Response to reviewers.

We have removed the mention of steady bidirectional flow in the title entirely to avoid confusion. The title is now: **Experimental Study of Time-averaged Flow and Turbulence over Asymmetric Tidal Dunes.**

Figure 7. Conceptual diagram showing the different quadrant events used to characterise turbulent events using quadrant analysis.

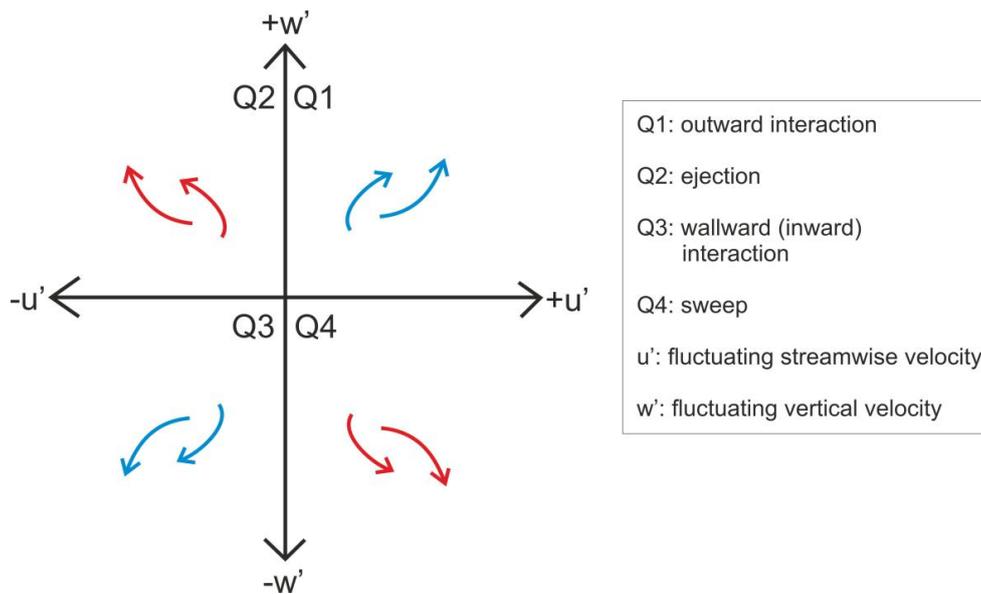
Methods and results: These sections are excellent. The analysis is detailed, systematic, and well-executed. The figures and interpretations convincingly support the conclusions. The only thing I would appreciate is a bit more explanation on the quadrant analysis and the interpretation of these results.

Regarding the quadrant analysis, we have provided a visual representation of these events. We have added Figure 7 for this purpose.

Figure 1: Types of dunes based on their morphology. TW: Turbulent wake.

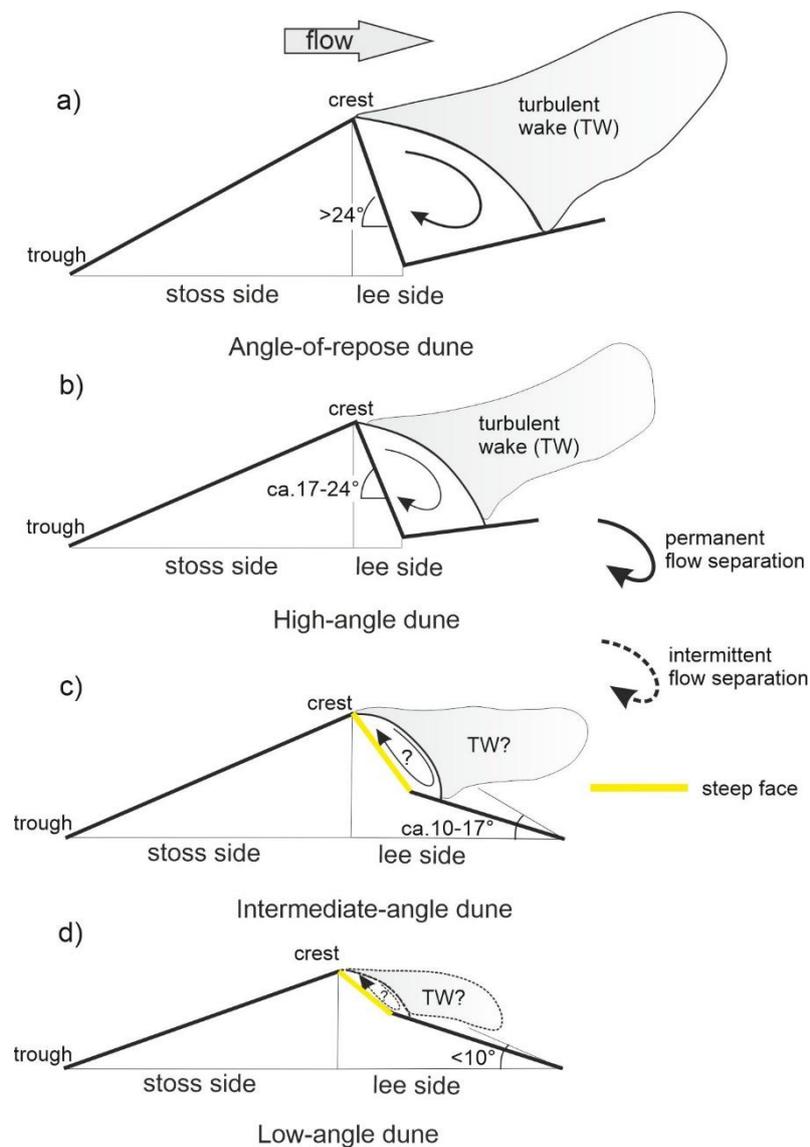
Line 78: maybe additionally define TW in the caption. Also, could you add the degrees for the steep face of the intermediate and low-angle dune?

We have added the definition of TW in the Figure caption as shown below.

Regarding the angles of the steep faces for the intermediate and low-angle dunes, I also thought of putting in the drawing. However, there is no clear range for the angle of steep face per type of dune. We have the angle of the steep face for our idealised dunes but I think this figure (Fig. 1) is more for general depiction of dunes so the angle of steep face is variable.

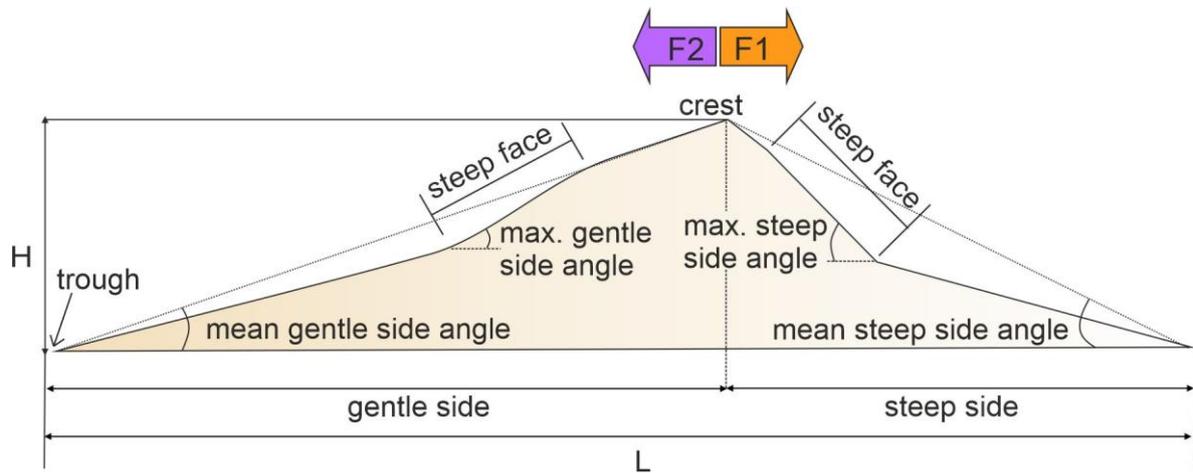
Line 139: can you add the meaning of H, L, F2 and F1 in the caption?

We have added their definitions in the Figure caption as shown below.

Figure 5. Laboratory tidal dunes and experimental flume setup.

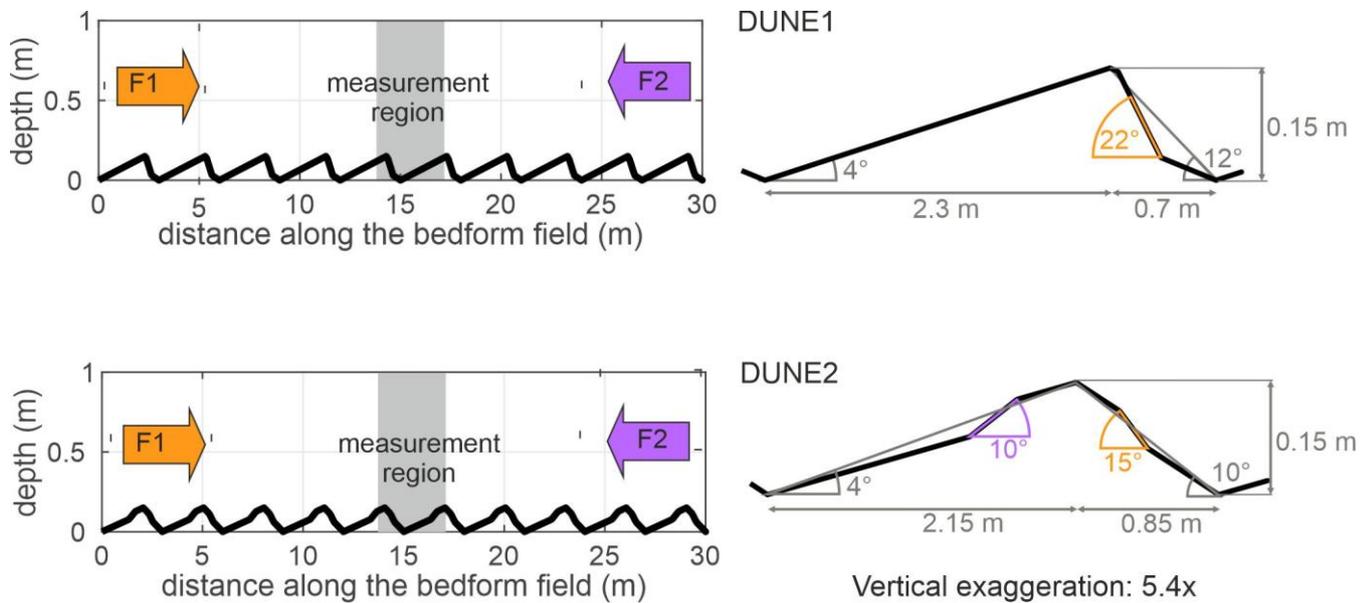
Line 161: The F1 and F2 sign in the left figures confuse me. They make it seem like of the measurement region, the left half is measured under F2, while the right half is measured under F1-conditions. Consider removing, or at least not aligning it so perfectly with the measurement region.

I just placed them at both sides of each figure to avoid confusion. But I think it is still good to show them to provide visuals for the flow directions. The new Figure 5 is shown below

Figure 7. Conceptual diagram showing the different quadrant events used to characterise turbulent events using quadrant analysis.

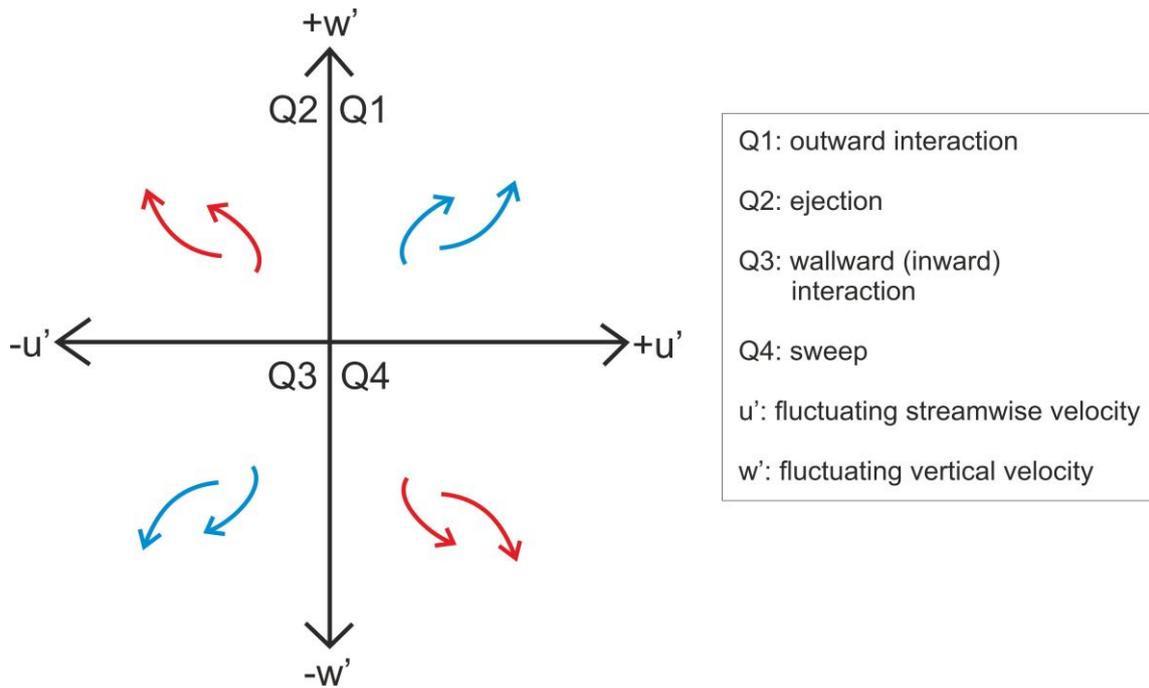
Lines 218-220: I find this a bit hard to grasp. Would it be possible to provide a visualisation of the quadrants and their meanings?

We have added a figure to provide visualisation to these quadrant events. It appeared as Figure 7 as shown below.

Figure 8. Time-averaged flow fields. I) DUNE1_F1, II) DUNE1_F2, III) DUNE2_F1, IV) DUNE2_F2.

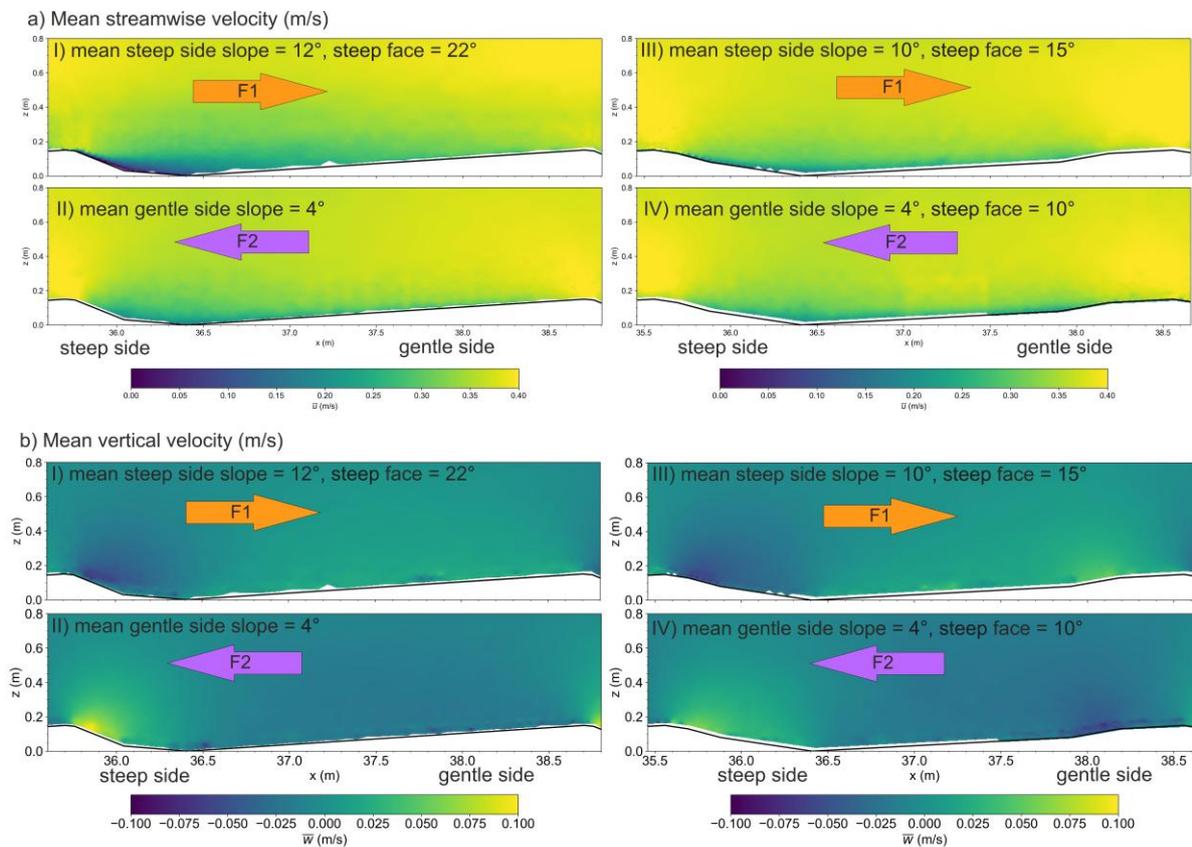
Line 239: I think it would improve the readability and main message of this figure, if the data is interpolated and shown as a surface plot instead.

We have replotted it as surface plots. It is shown as Figure 8 shown below

Figure 11. Vertical gradient of time-averaged horizontal velocity, $\partial\bar{u}/\partial z$ (1/s). a) DUNE1_F1, b) DUNE2_F1, c) DUNE1_F2, d) DUNE2_F2.

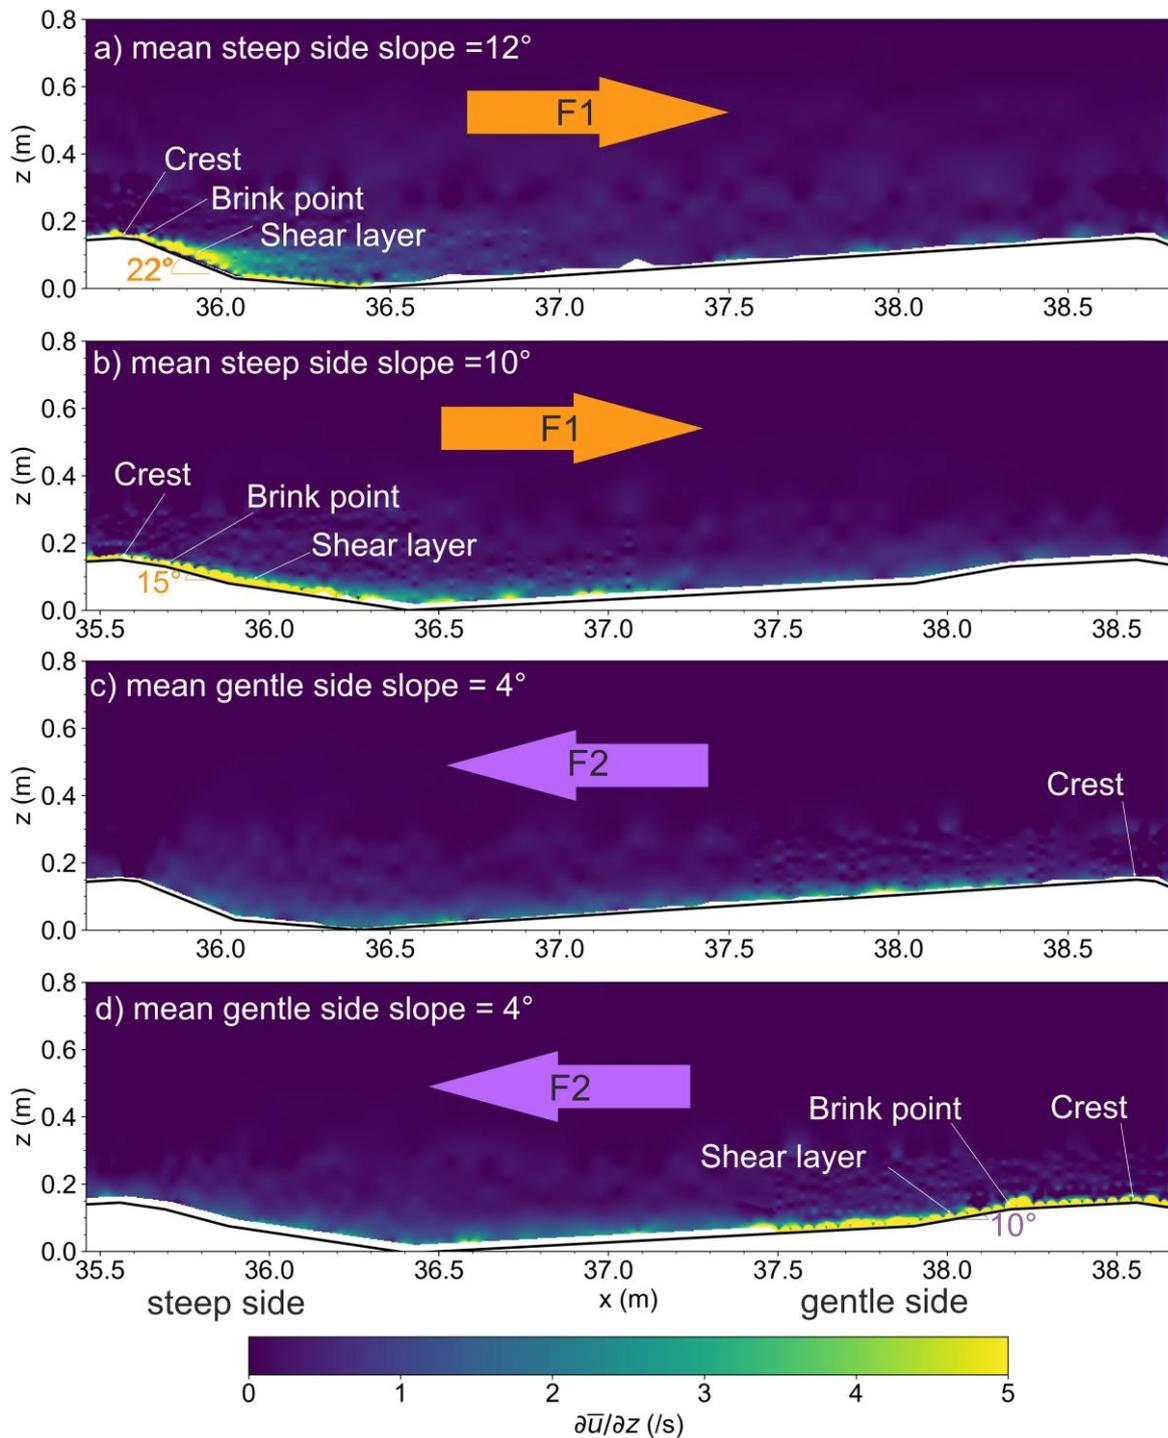
Lines 271-273: I think it might be beneficial to the readability to zoom in, just like you did in Figure 9.

I enlarged the figure similar to Figure 9. It appeared now as Figure 11.
